Docket Nos. 50-269
50-270
and 50-287

The Commission has issued the enclosed Amendment Nos. 53, 53 and 50 for License Nos. DPR-38, DPR-47 and DPR-55 for the Oconee Nuclear Station, Unit Nos. 1, 2 and 3. These amendments are in response to your application dated November 9, 1977.

These amendments revise the Technical Specifications to allow operation of Oconee Unit 1 Cycle 4 at 100% full power with a flux tilt of 6.03% in an unrodded mode.

ATTACHMENT TO LICENSE AMENDMENT NOS. 53, 53AND 50
FACILITY OPERATING LICENSE NOS. DPR-38, DPR-47 AND DPR-55
DOCKET NOS. 50-269, 50-270 AND 50-287

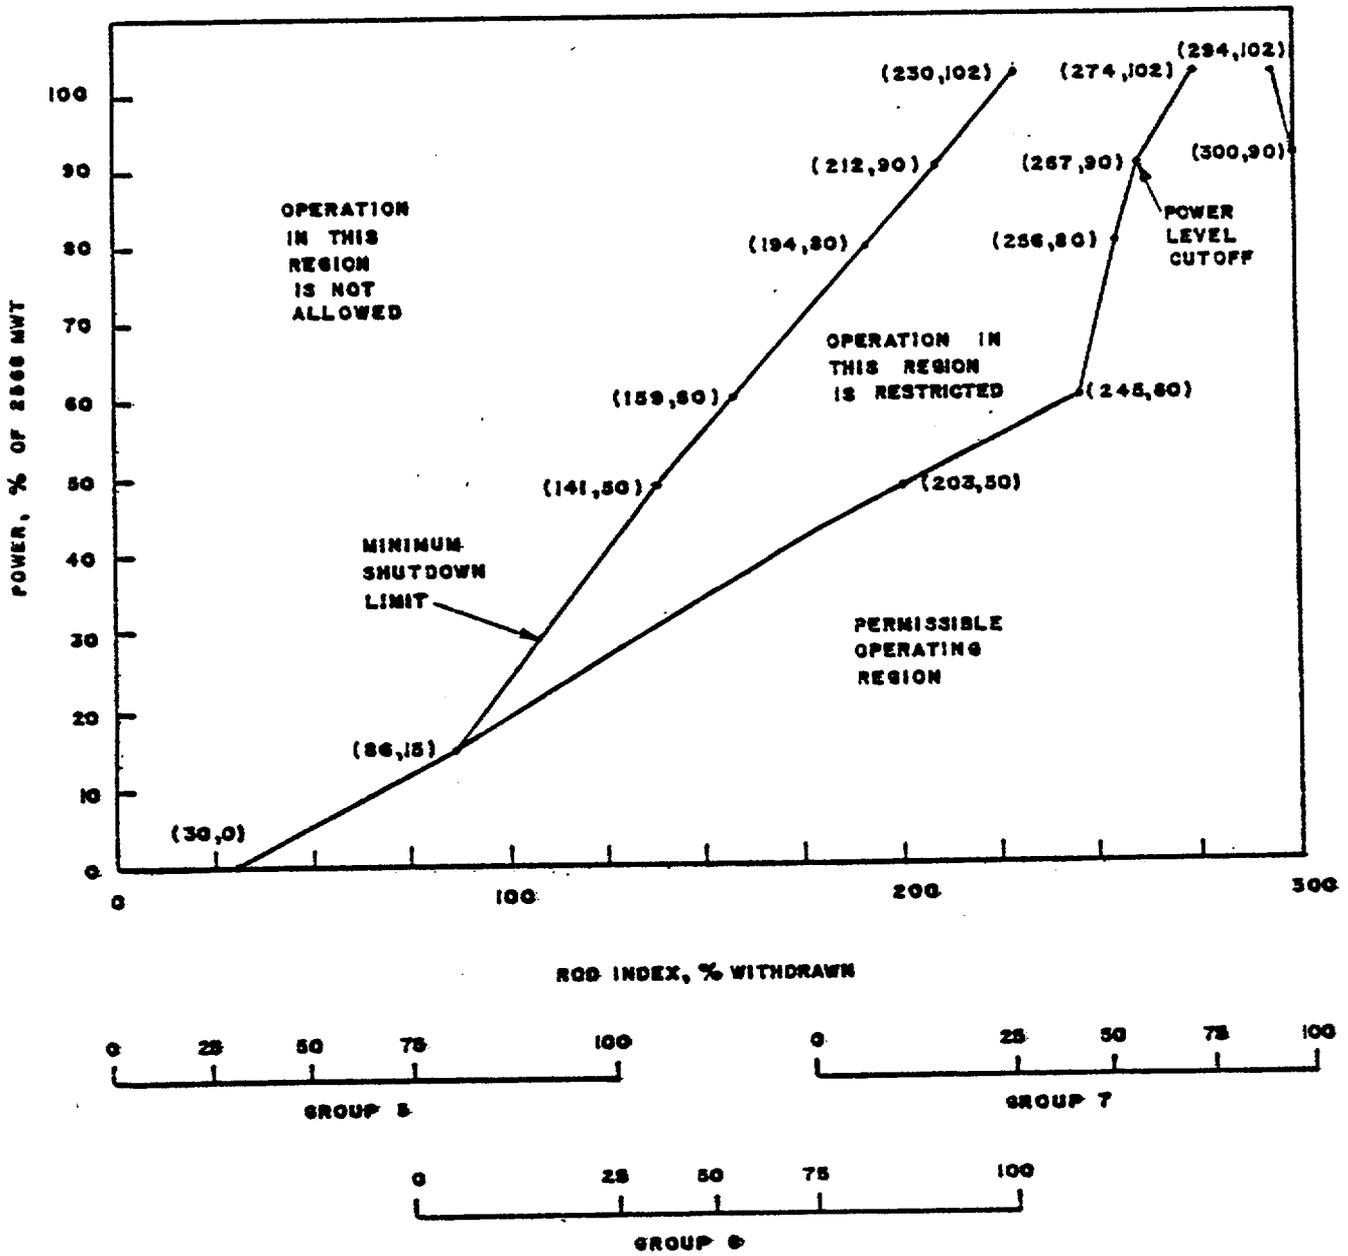
- c. Position limits are specified for regulating and axial power shaping control rods. Except for physics tests or exercising control rods, the regulating control rod insertion/withdrawal limits are specified on figures 3.5.2-1A1, (Unit 1); 3.5.2-1B1, 3.5.2-1B2 and 3.5.2-1B3 (Unit 2); 3.5.2-1C1, 3.5.2-1C2 and 3.5.2-1C3 (Unit 3) for four pump operation, and on figures 3.5.2-2A1, (Unit 1); 3.5.2-2B1, 3.5.2-2B2 and 3.5.2-2B3 (Unit 2); 3.5.2-2C1, 3.5.2-2C2 and 3.5.2-2C3 (Unit 3) for two or three

- d. Except for physics tests, power shall not be increased above the power level cutoff as shown on Figures 3.5.2-1A1, (Unit 1), 3.5.2-1B1, 3.5.2-1B2, and 3.5.2-1B3 (Unit 2), and 3.5.2-1C1, 3.5.2-1C2, 3.5.2-1C3 (Unit 3), unless the following requirements are met.

Figure 3.5.2-1A1

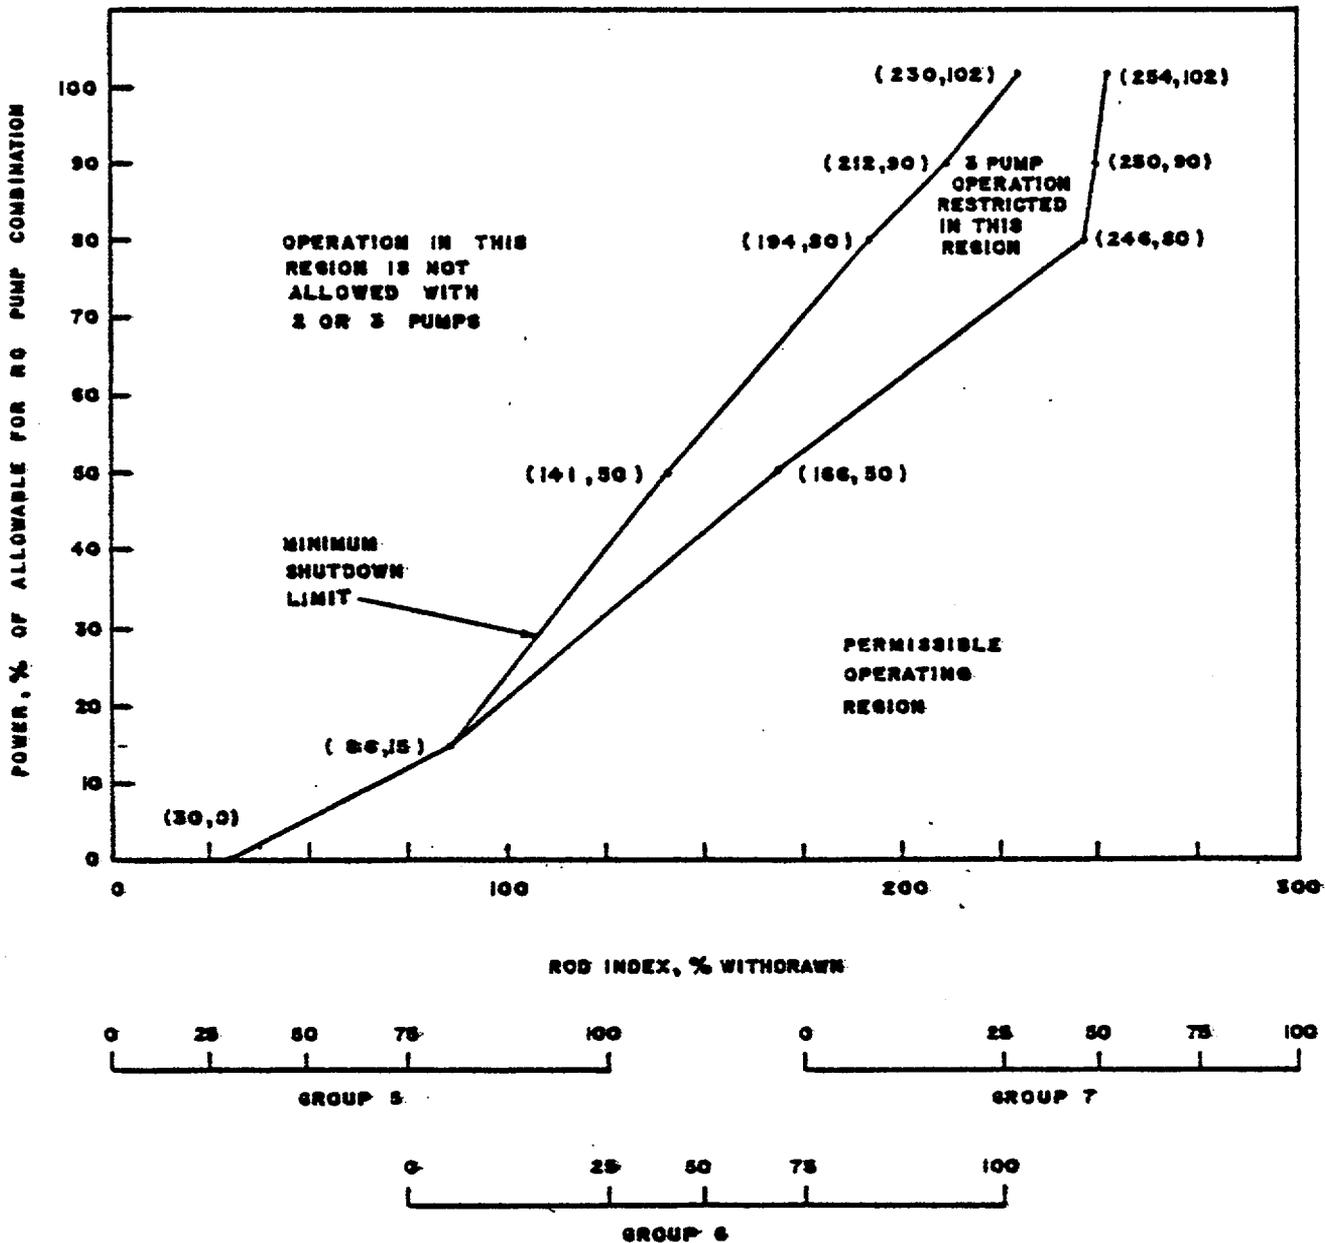
OCONEE 1 CYCLE 4 ROD POSITION LIMITS FOR FOUR PUMP OPERATION FROM 0 TO 100 (+10) EFPD
